ADDENDUM NO. 2
Dr. Joyce M. Cusack Resource Center
CITY OF DeLAND
BID NO. 19-09
February 13, 2019

The following items are clarifications, corrections or deletions to the contract documents. **THIS ADDENDUM TAKES PRECEDENCE OVER THE ORIGINAL PARTS OF THE CONTRACT DOCUMENTS.**

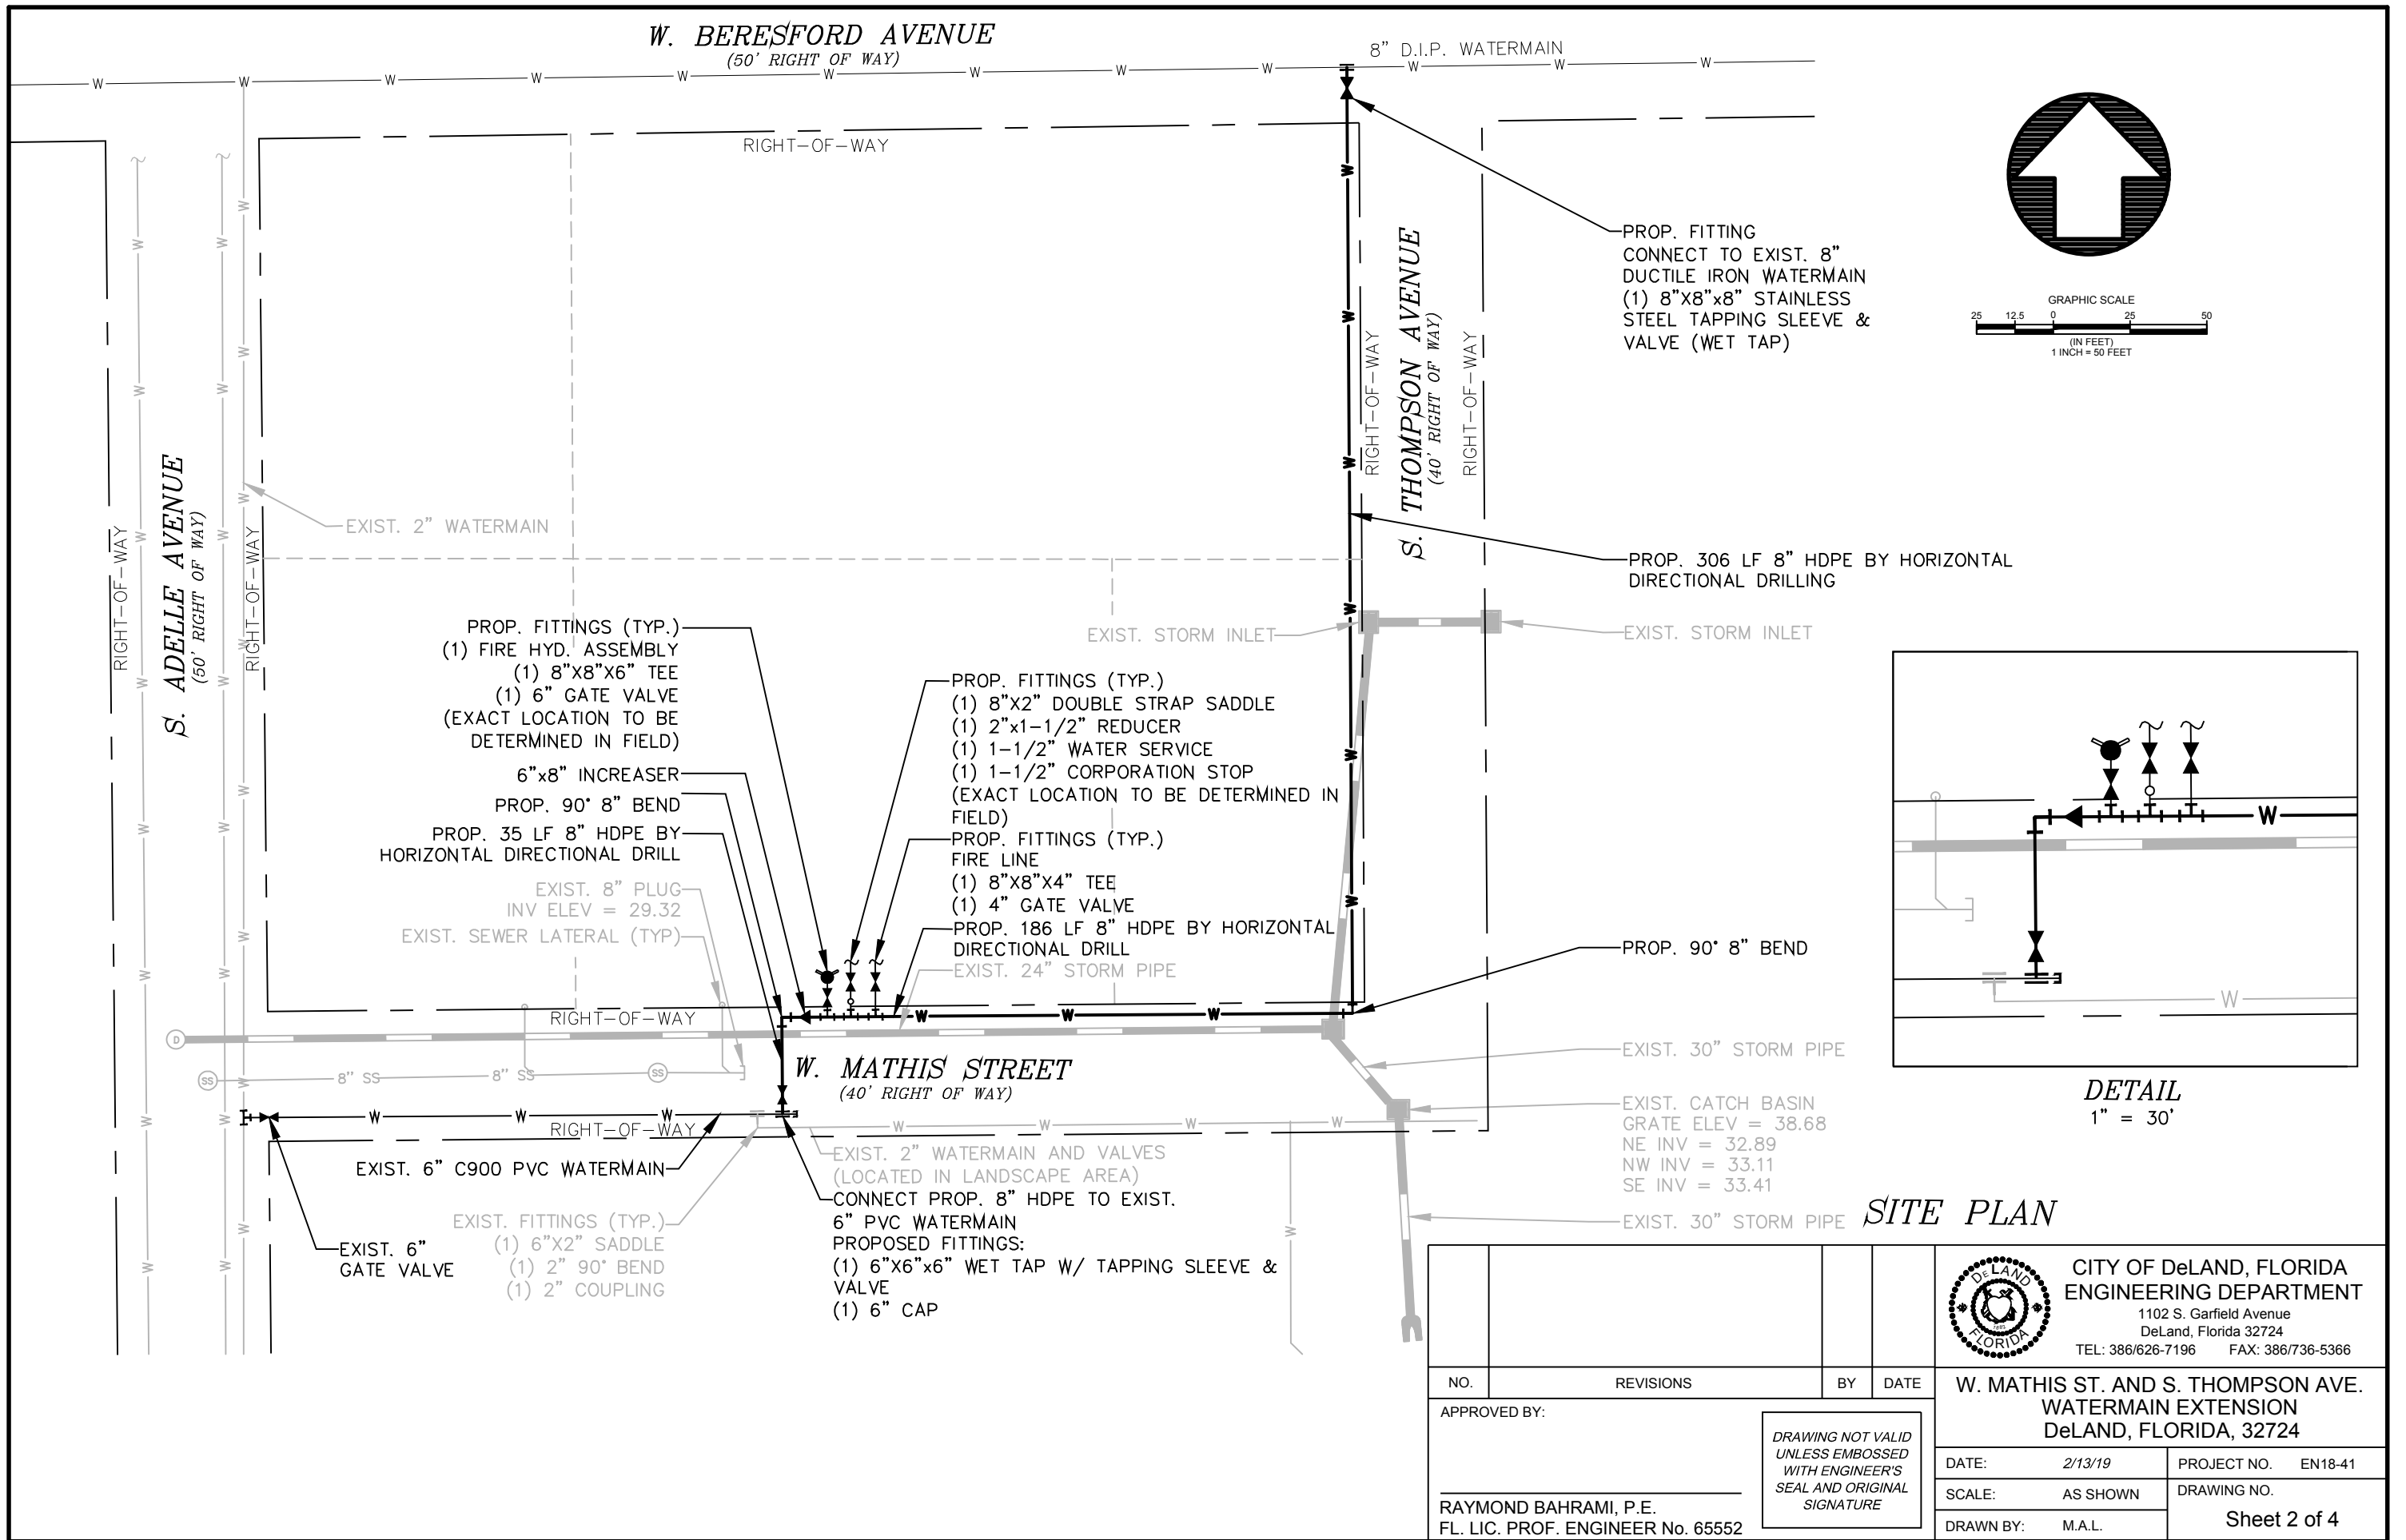
- e. Can't locate on Civil Sheets where the fire line for the sprinkler system is to tie into the building and hook up. *Water service will be provided to the building south property boundary by others. The attached sketch depicts approximate locations of the fire and domestic service connections.*
